Land North East of M42 Junction 10

Highways Statement of Common Ground between National Highways and Hodgetts Estates

Appeal Reference: APP/R3705/W/24/3336295

May 2024

Sheet Title
**PROPOSED LAYOUT
 SHEET 1**

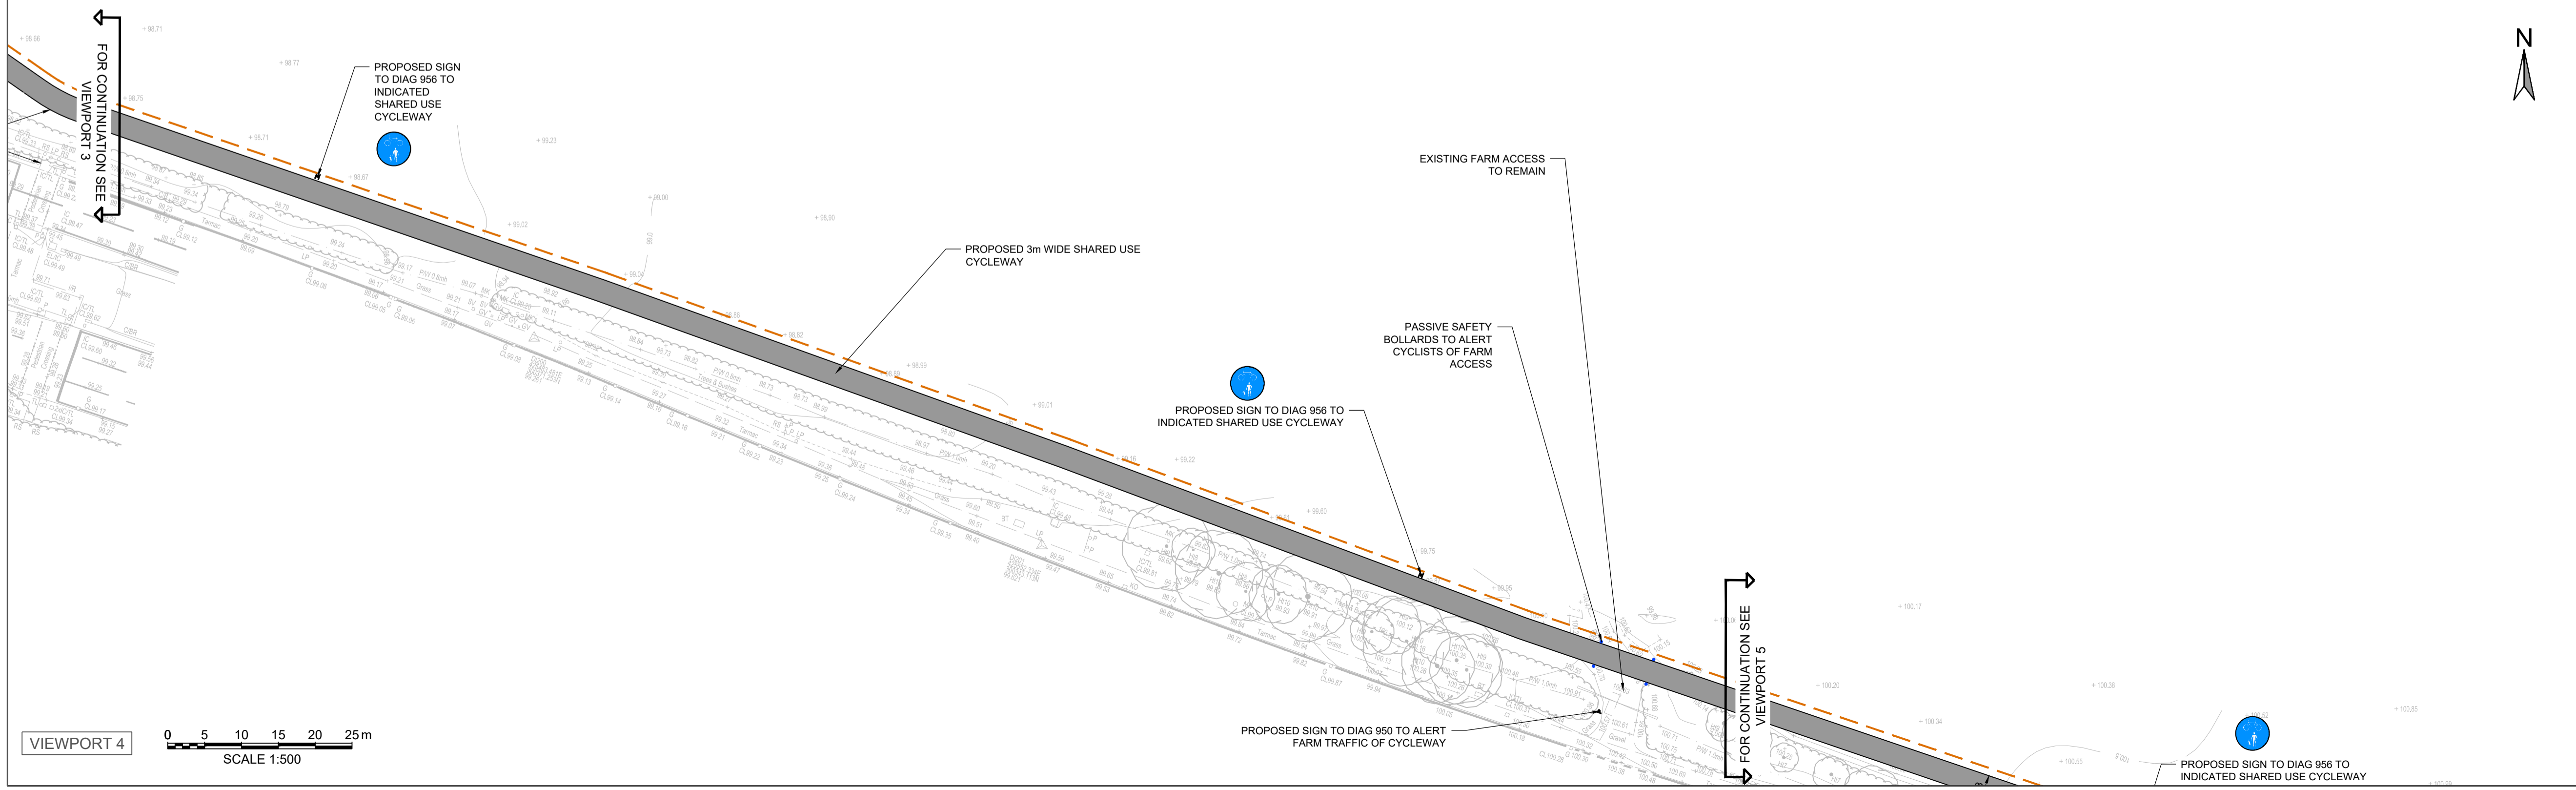
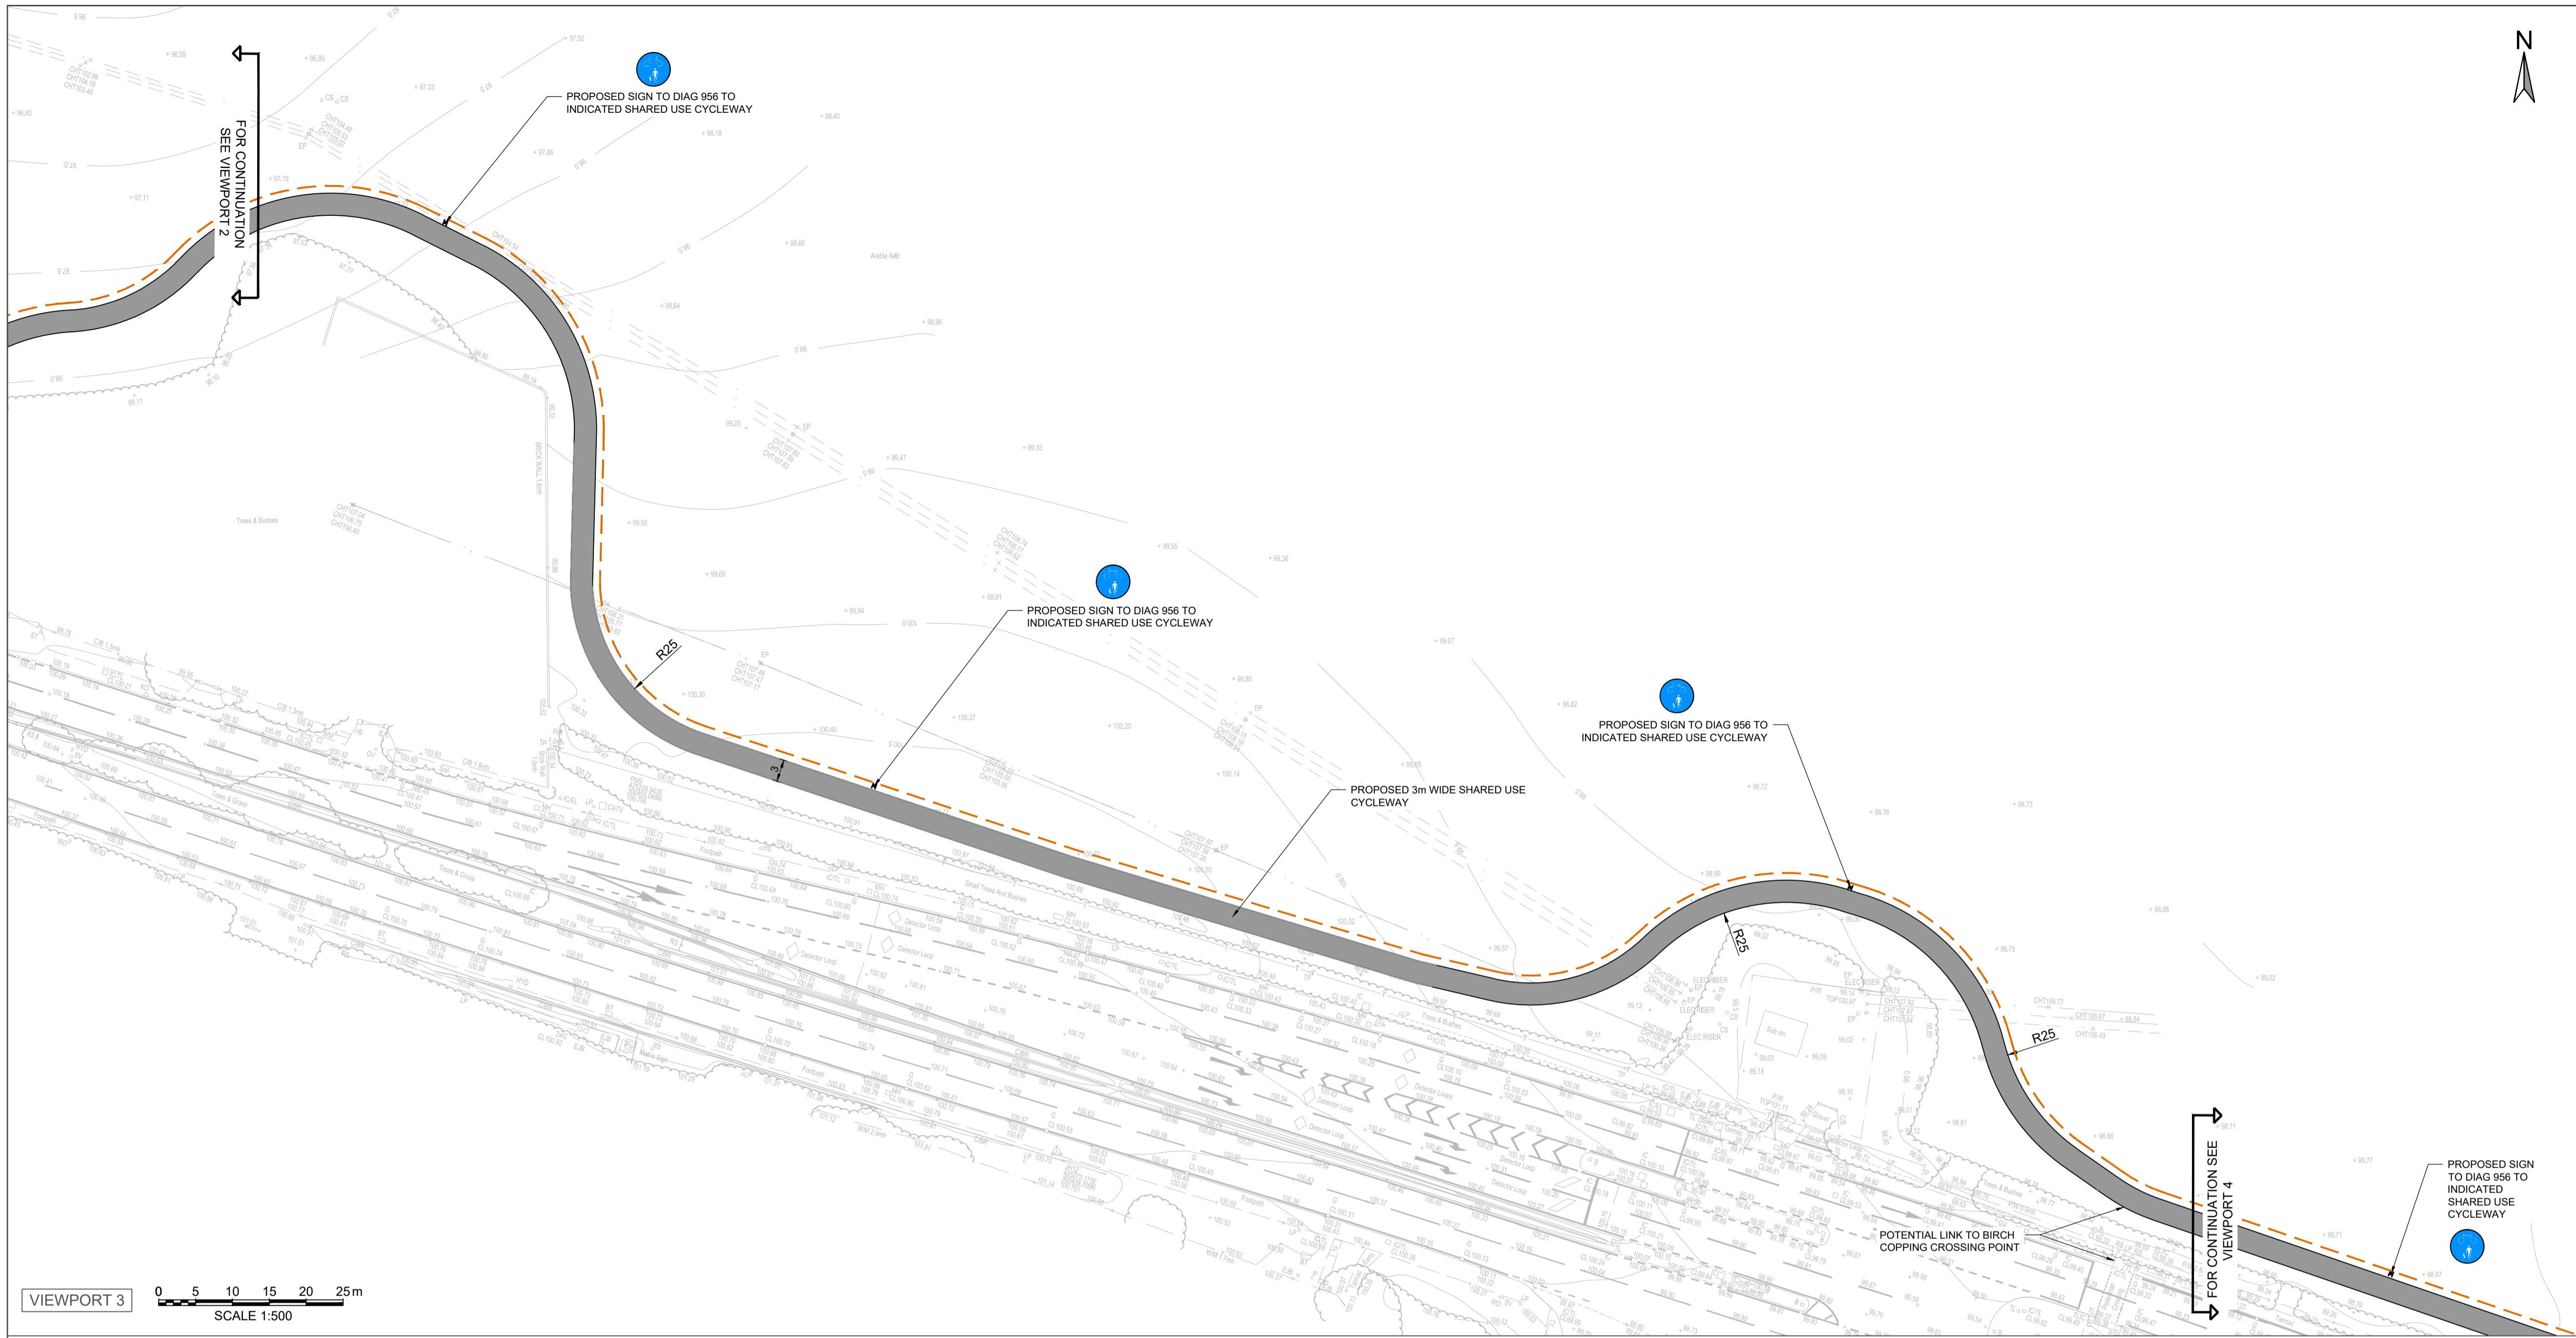
- 11.3 NH in their email dated 2 May 2024 confirmed that the layout cycleway was acceptable in principle, and that the design comments could be addressed at subsequent design stages.

- The layout of the proposed cycleway measures shown in the above TT drawings are acceptable in principle.
- The design comments identified in the review can be addressed at subsequent design stages.
- The cycleway improvement can be provided within land forming part of the A5, or land under the control of the Appellant.

- With regard to the proposed cycle route, it would be useful to understand if there is an intention to extend the signalisation of the crossing points to include M42 J10 to provide a continuous safe route. This looks to be the case having looked at the additional drawing – But needs confirmation.

- The plans indicate that both laybys on the East and Westbound A5 will be removed. There is currently limited provision for rest breaks along the A5. It would be useful to understand the proposal for alternative provision for drivers.
